SECTION 00 91 12

ADDENDUM NUMBER 4**PARTICULARS****1.01 DATE: MARCH 1, 2022****1.02 PROJECT: PIERPONT VET TECH****1.03 OWNER: WV HIGHER EDUCATION****1.04 ARCHITECT: PICKERING ASSOCIATES****TO: PROSPECTIVE BIDDERS:**

2.01 THIS ADDENDUM FORMS A PART OF THE CONTRACT DOCUMENTS AND MODIFIES THE ORIGINAL PROCUREMENT DOCUMENTS DATED FEBRUARY 1, 2022, ADDENDUM NUMBER 1 DATED FEBRUARY 14, 2022, ADDENDUM NUMBER 2 DATED FEBRUARY 21, 2022 AND ADDENDUM NUMBER 3 DATED FEBRUARY 23, 2022, WITH AMENDMENTS AND ADDITIONS NOTED BELOW.

Project:	2201011
Designed By:	JMC
Drawn By:	JMC
Checked By:	SLK
Scale:	1"=10'
Plot Date:	02/25/22
Revision:	1
Drawing Number:	C105

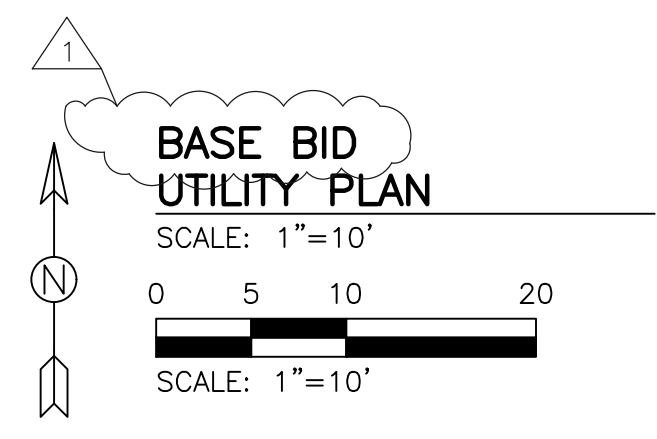
1. See revisions shown bubbled on the following attached reissued 24 x 36 Drawings:
 - a. Civil: C105 (Sanitary Service line tie-in information).
 - b. Structural: S112 (Roof framing revision for roof hatch).
 - c. Architectural: A111 & A302 (Addition of roof hatch & ladder in Storage Room 030).
 - d. Electrical: E122, E130, E501, E600 & E601 (Misc. revisions).
2. Add attached 24 x 36 Electrical Drawing E123 – Site Power Plan Alt. No. 4 (light for Monument Sign).

Q1: The site plans show the new sanitary service for the addition but does not show where it ties into the local utility service line. Can this information be provided?

A1: See attached Drawing C105 for information regarding tie-in to existing sanitary service line.

Drawing Number:
A111

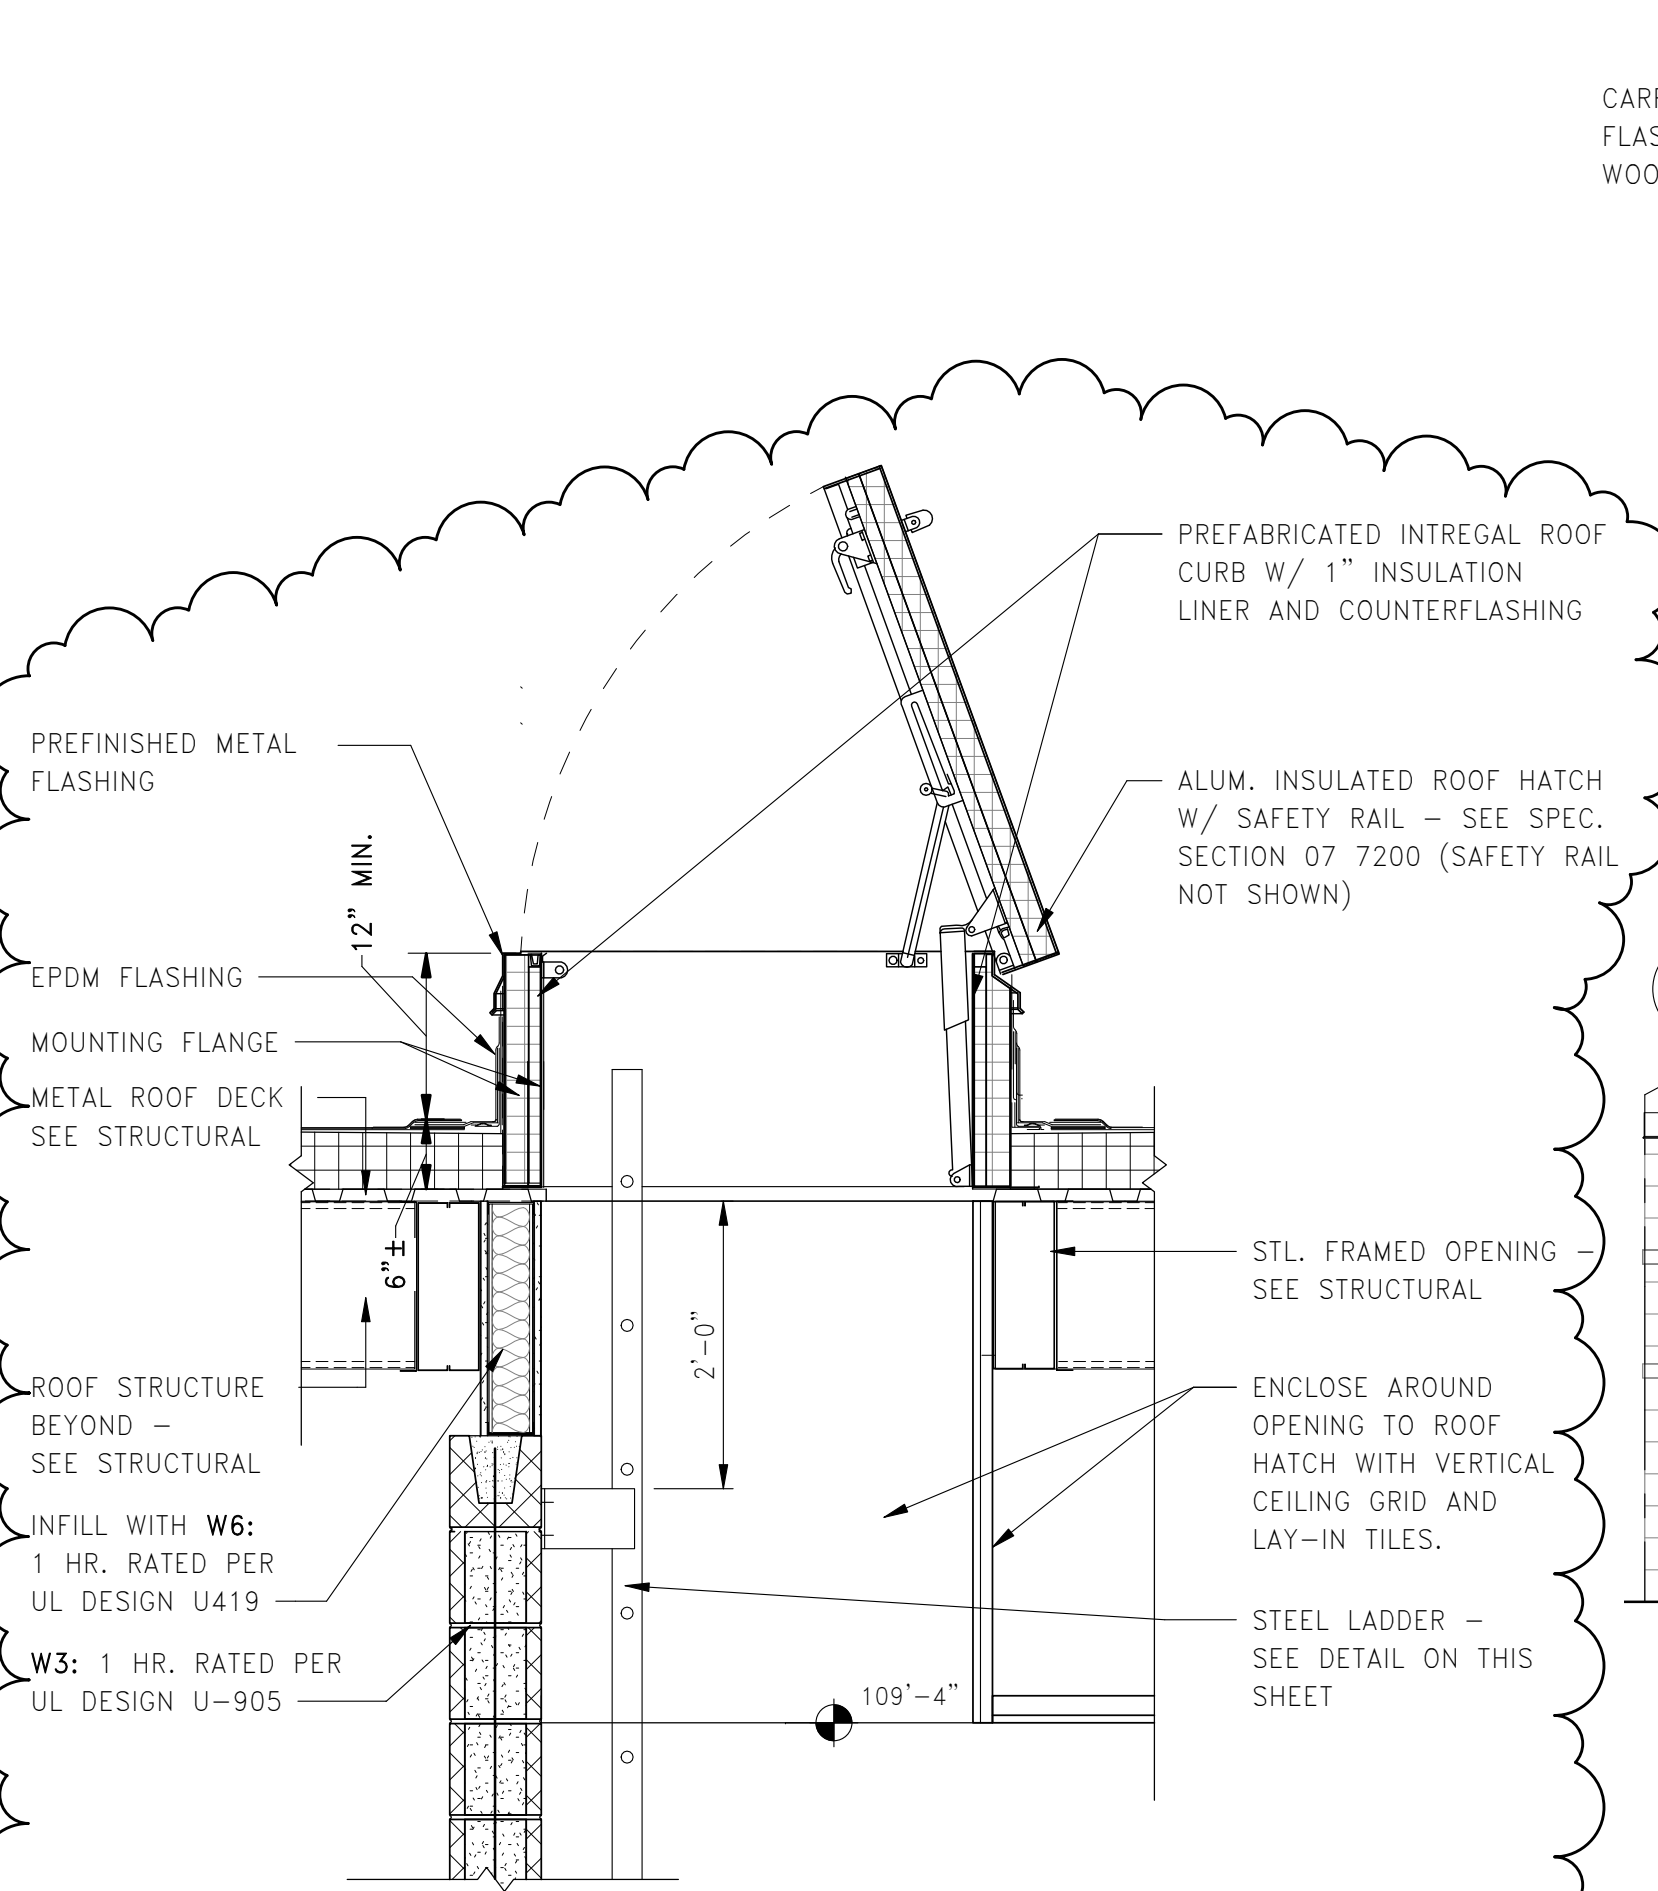
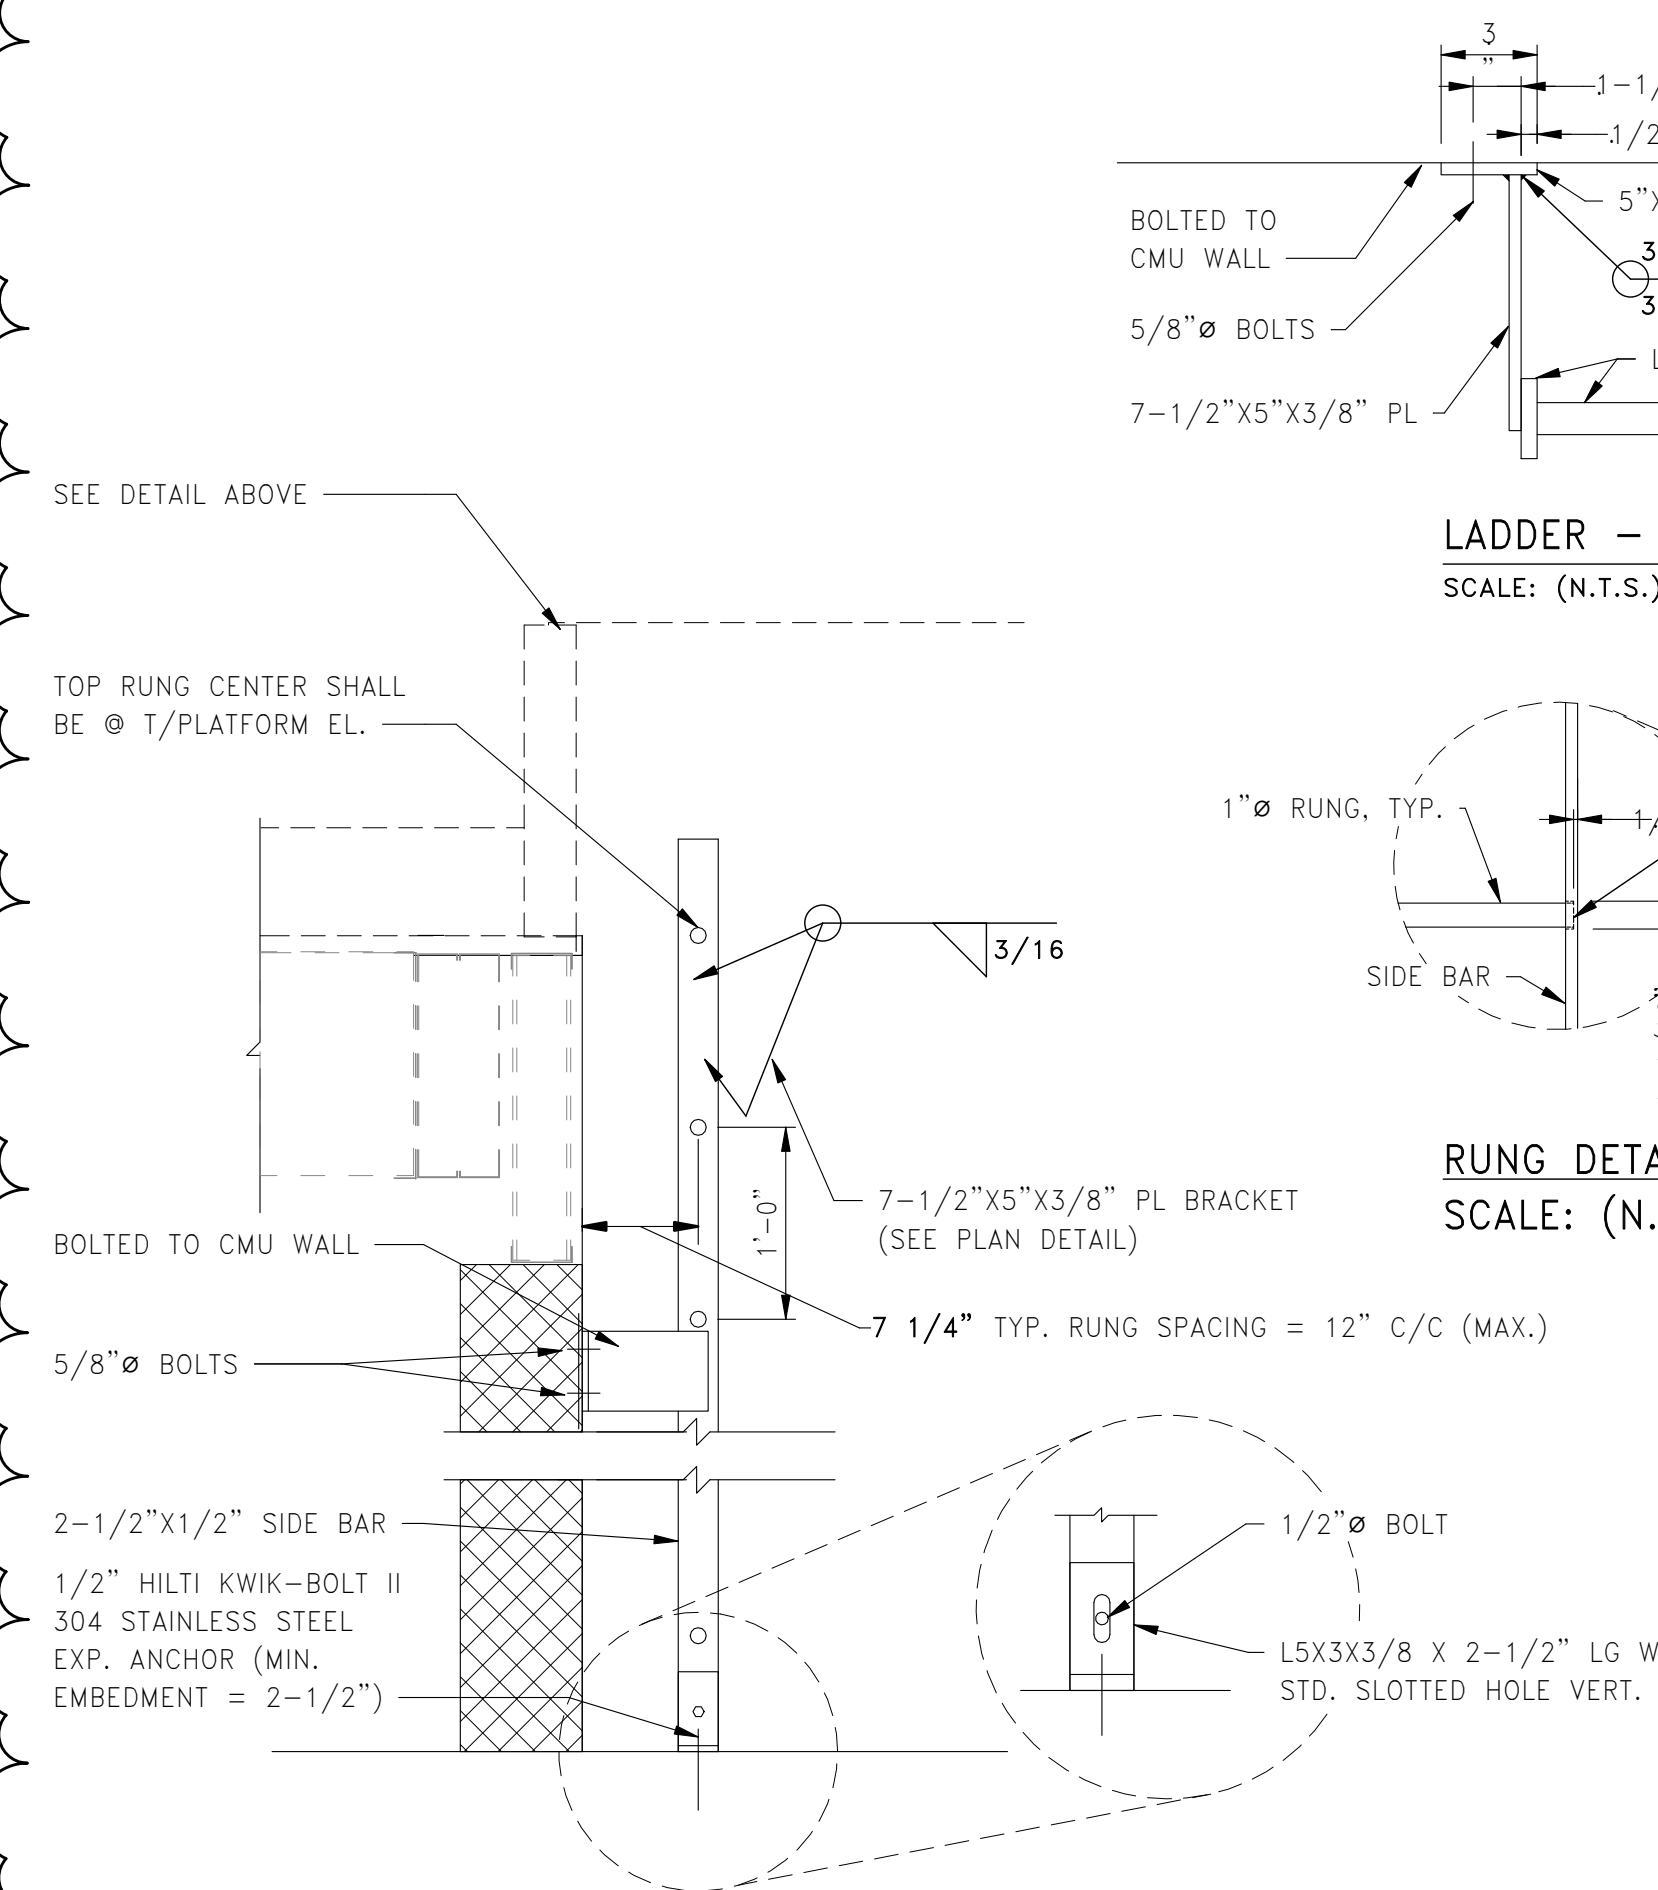
3. Civil Drawings and Specifications: General Clarification Note: Follow all Geotechnical recommendations for over-excavation, engineered fill replacement and all subgrade preparations, typical. Refer to Geotechnical Report in the Project Manual.
4. Drawing A112 – Roof Plan: Clarification: Provide crickets on upper slope of roof hatch to direct water around roof hatch to drains. Revise location of walkway pads to extend from roof hatch to rooftop unit (same quantity of walkway pads will be required that are shown on roof plan). See attached Drawing A111 for roof hatch location.
